**Errata: CS43L41 Rev. C**CS43L41 Low Power 24-Bit, 96 kHz DAC with Volume Control

Figure 1. I<sup>2</sup>C SCL Buffer Example

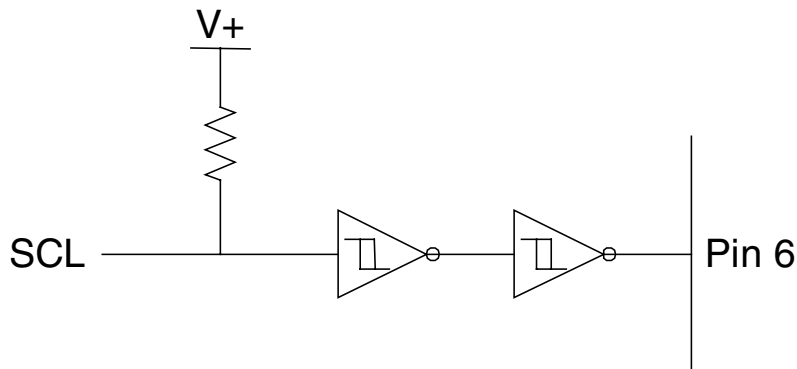
Pin 6 (SCL/CCLK) of the CS43L41 does not have sufficient hysteresis to meet the data sheet rise time specifications. The I<sup>2</sup>C rise time  $t_r$  and the SPI rise time  $t_{r2}$  must be less than 30 ns for proper operation. This prevents the use of standard I<sup>2</sup>C configurations with a resistor pull-up. This problem can be worked around by placing a Schmitt Trigger buffer, for example a 74HC14, on the SCL line just prior to the CS43L41. This will not affect the operation of the I<sup>2</sup>C bus as pin 6 is an input only.
